Structure at the Crossing of
Gravel River #1 and
Relocated Hwy. 129 (Line M)
District #18 (Sault Ste Marie)
W.P. 14-74-08, Site No. 385-331 332

Structure at the Crossing of
Gravel River #1 and
Relocated Hwy. 129 (Line M)
District #18, (Sault Ste. Marie)
W.P. 14-74-08, Site No. 38S-331

SOILS INVESTIGATION
NEW STRUCTURE OVER GRAVEL RIVER NO. 1
(WP 14-74-08)
DISTRICT #18
SAULT STE. MARIE, ONTARIO

Re: Gravel River Bridge No. 1
Hwy. 129 (Line M)
W.P. 14-74-08, Site 38S-331
District 18, Sault Ste. Marie

GRAIN SIZE DISTRIBUTION

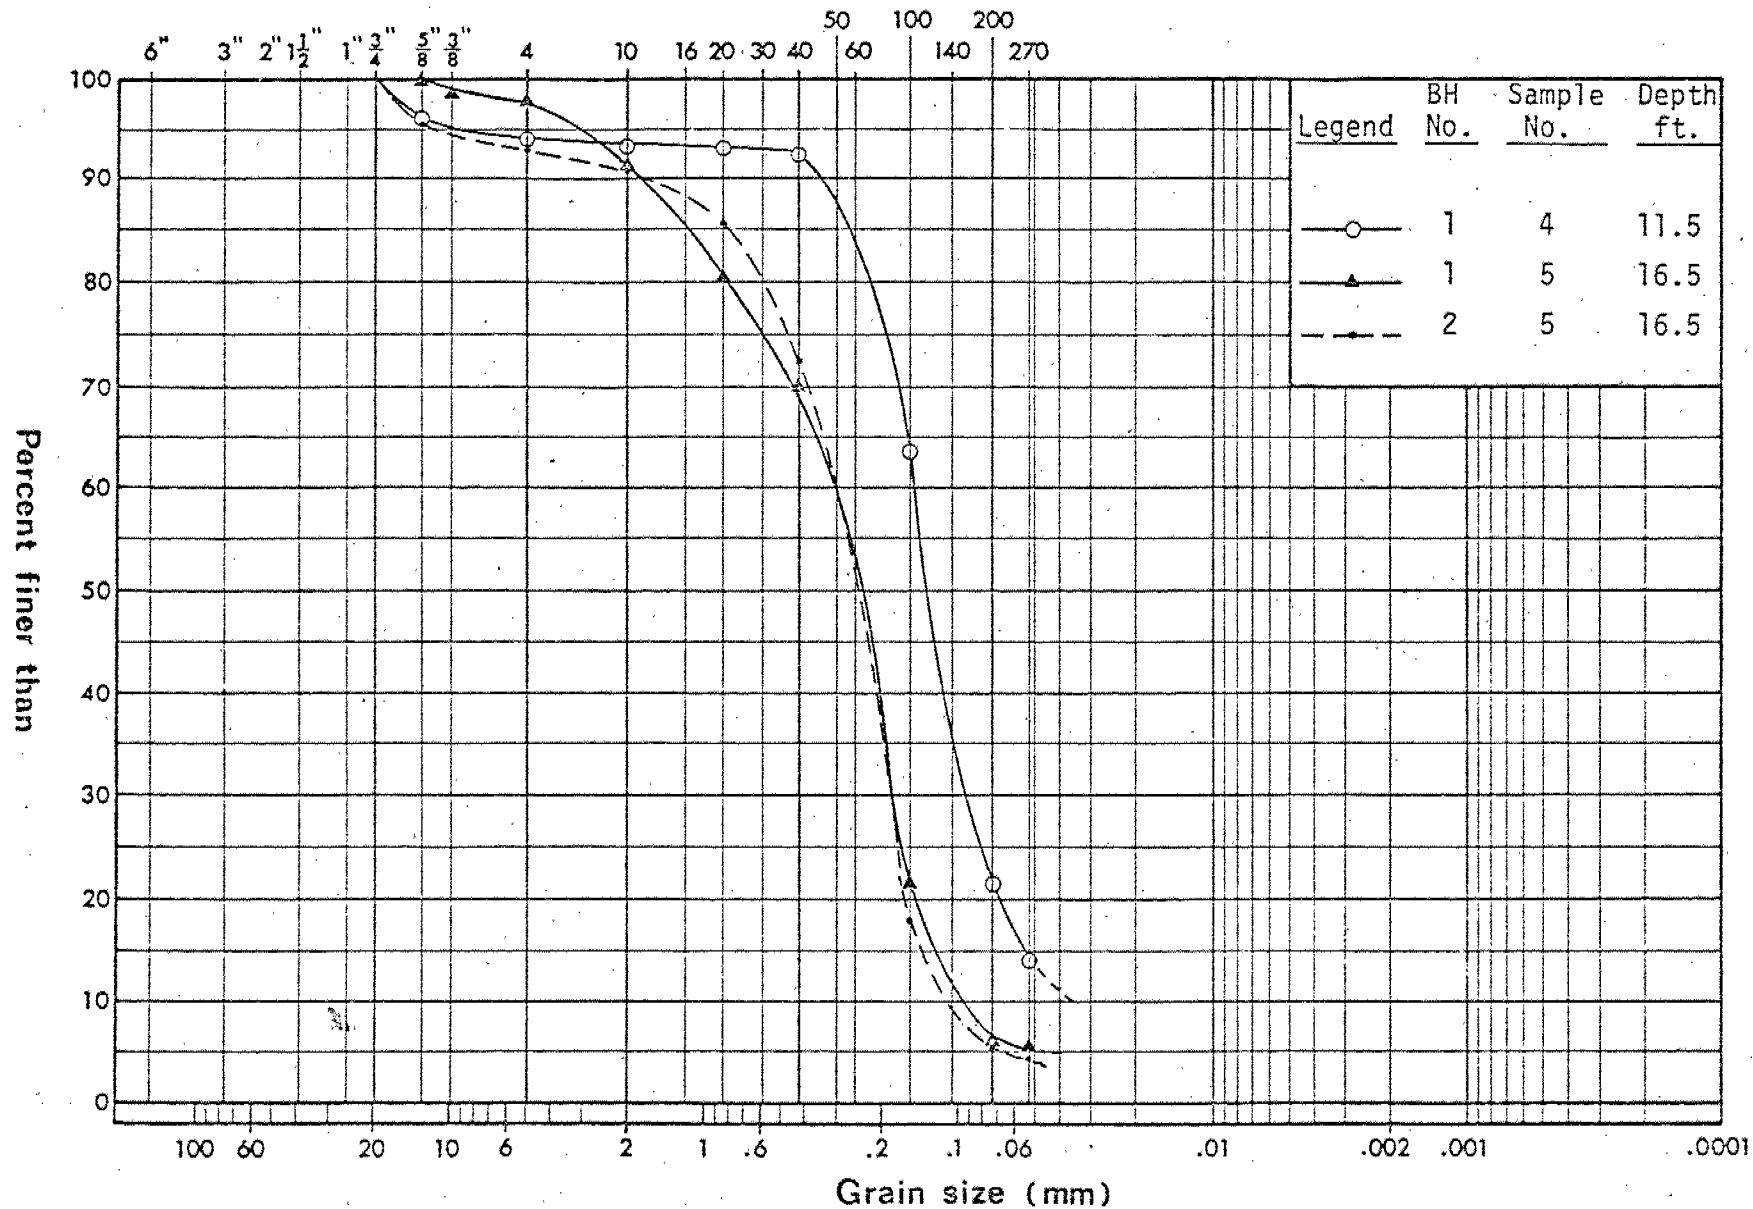
As per your request by telephone on July 15th, 1977, enclosed please find a figure showing the results of gradation tests performed on representative samples recovered from the sand stratum at the above site.

Sizes of cobbles and boulders encountered in the excavated probe holes range from 4 to 5 inches and 8 to 10 inches respectively. However boulders up to 16 inches in size were observed on the existing bed of the river channel. The above information on sizes of cobbles and boulders must be regarded as approximate only since they are the recollection of our field staff and not the actual measurements.

GRAIN SIZE DISTRIBUTION

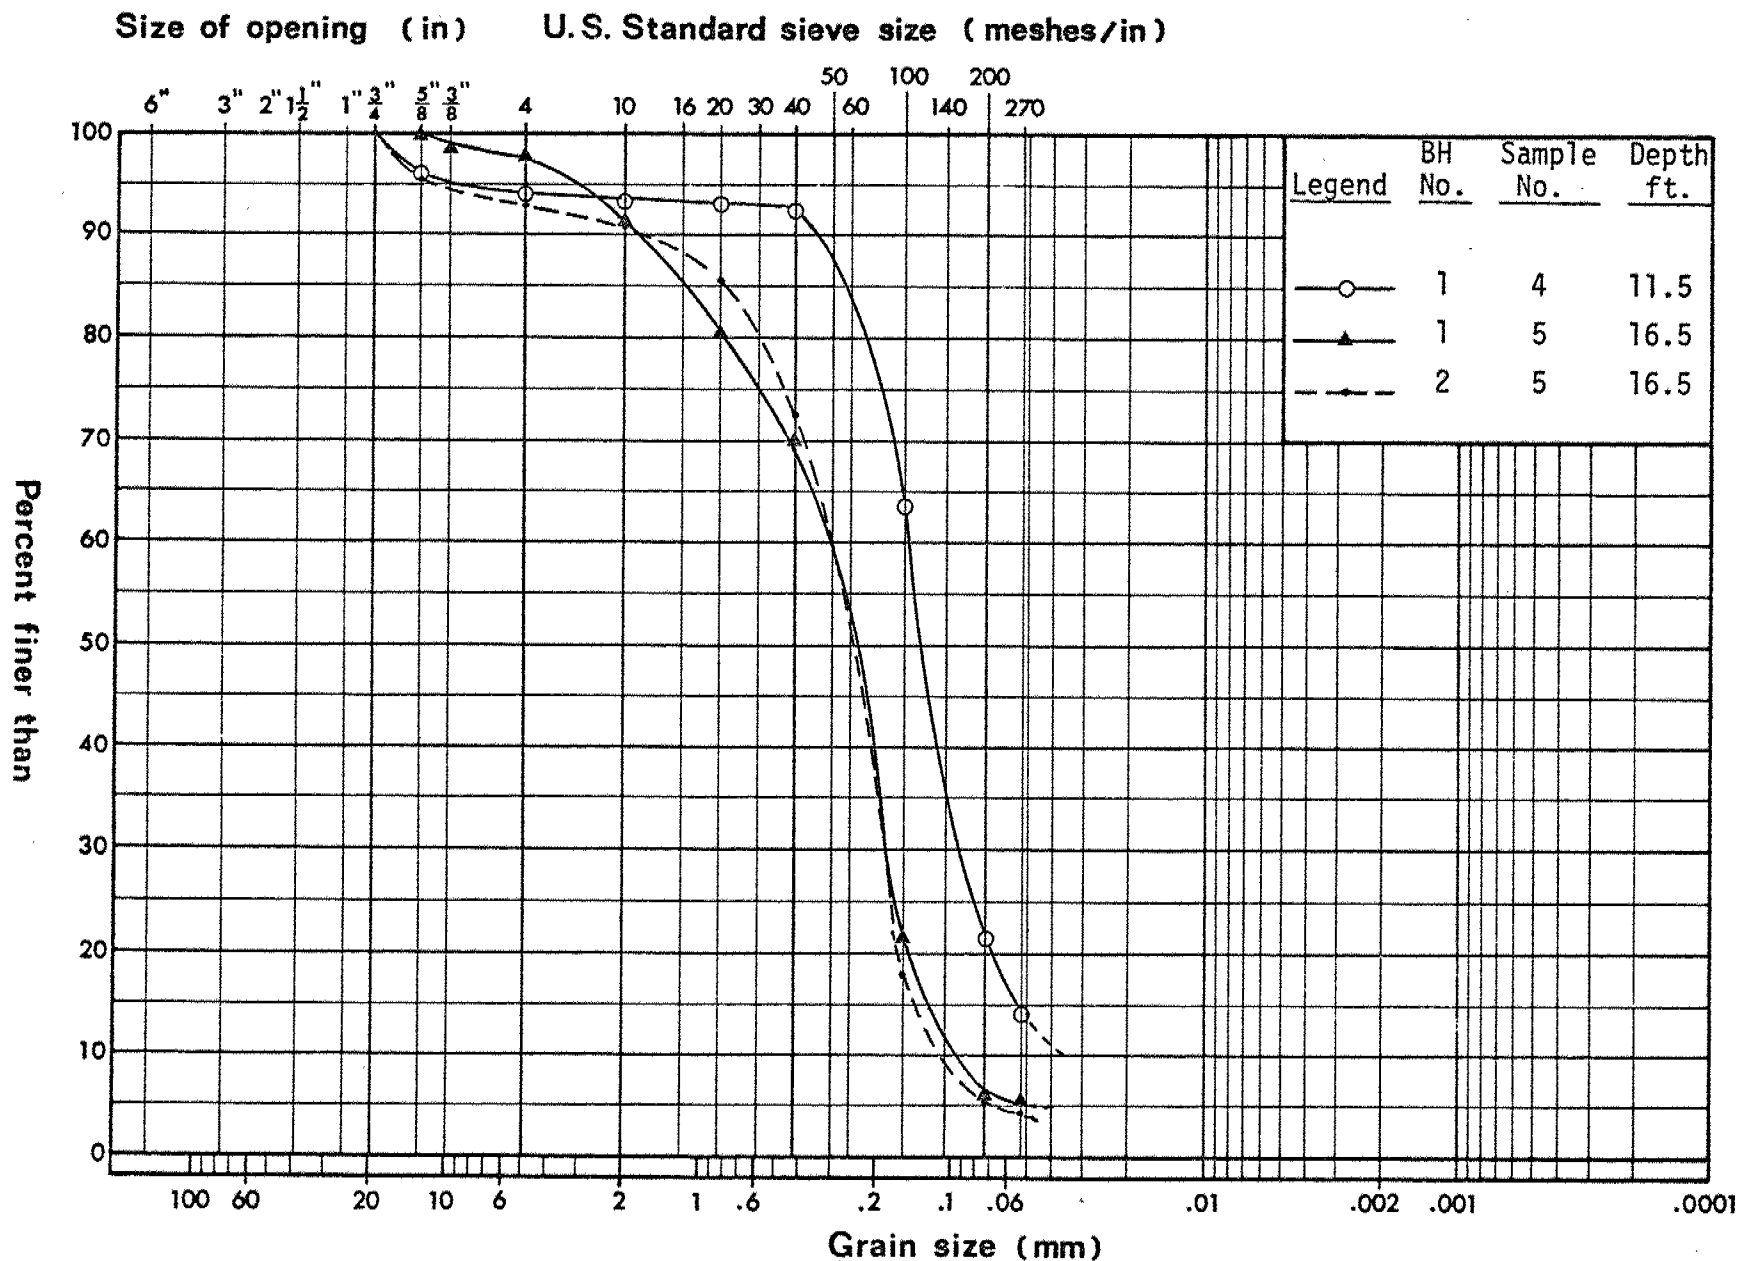
As per your request by telephone on July 15th, 1977, enclosed please find a figure showing the results of gradation tests performed on representative samples recovered from the sand stratum at the above site.

Sizes of cobbles and boulders encountered in the excavated probe holes range from 4 to 5 inches and 8 to 10 inches respectively. However boulders up to 16 inches in size were observed on the existing bed of the river channel. The above information on sizes of cobbles and boulders must be regarded as approximate only since they are the recollection of our field staff and not the actual measurements.
